Detailed criteria amendments to:

H1 (10) South of Sutton Road and H1 (11) Springfield

H1 (11) SPRINGFIELD, ROYAL ENGINEERS ROAD AND MILL LANE MAIDSTONE

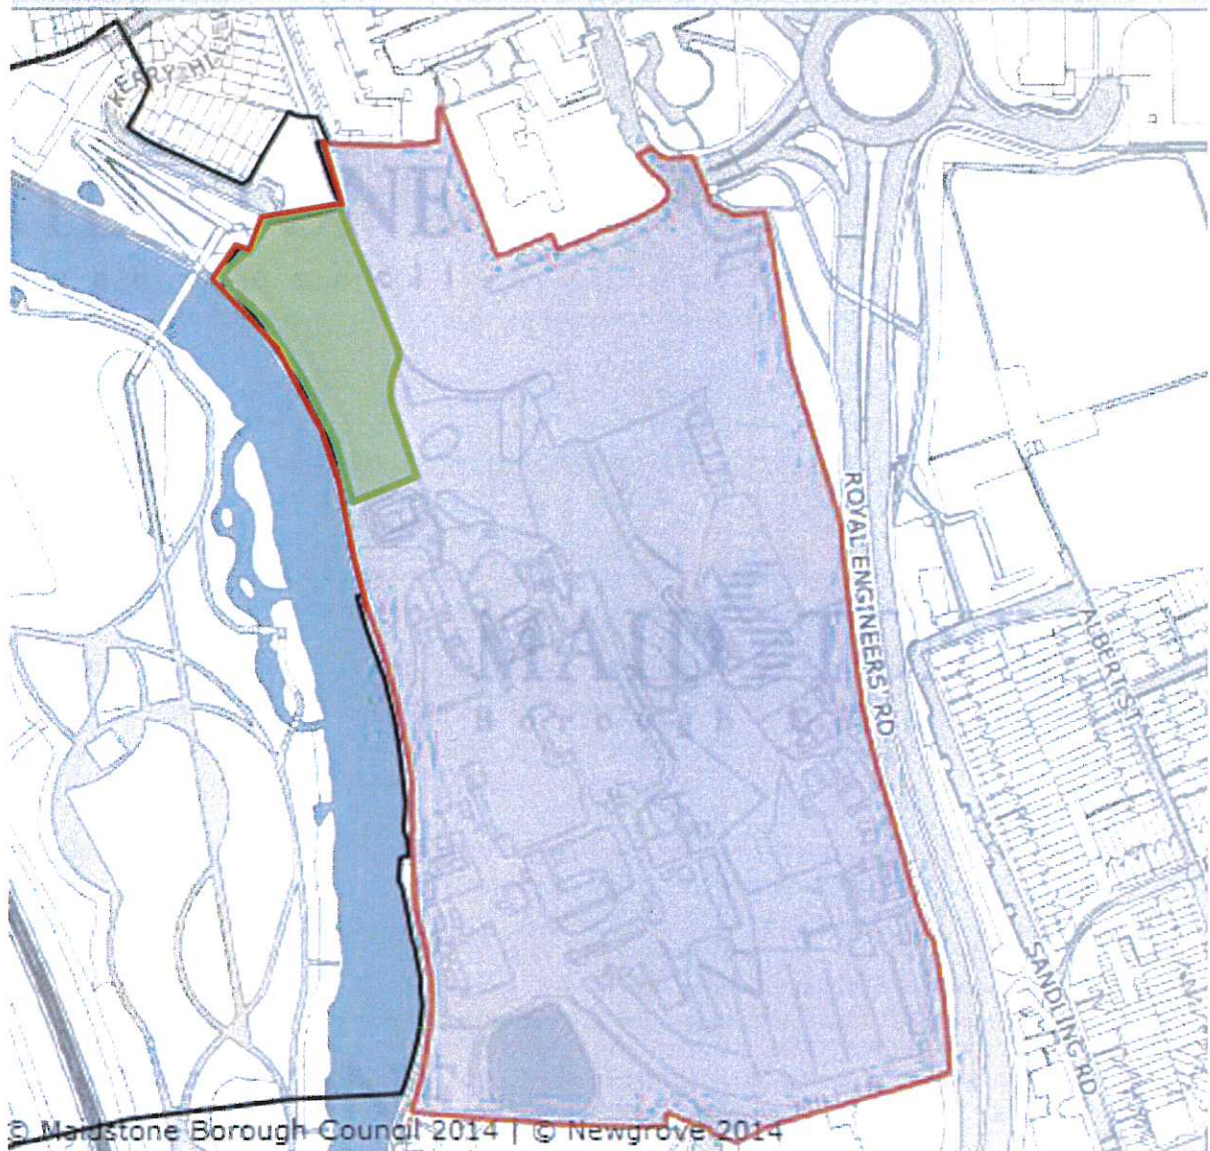
<p>H1 (11)</p>	<p>Springfield, Royal Engineers Rd and Mill Lane, Maidstone</p>	<p>Amend criterion 10 to state:</p> <p>Provision of publicly accessible open space <u>to include the provision of a pocket park to the rear (west) of the existing Springfield Mansion on the former tennis court/car park area in addition to the existing area of public open space shown on the Proposals Map which shall be retained as part of the development</u> and/or contributions.</p>	<p>To ensure appropriate open space to serve the occupiers of the development is secured</p>
----------------	---	---	--
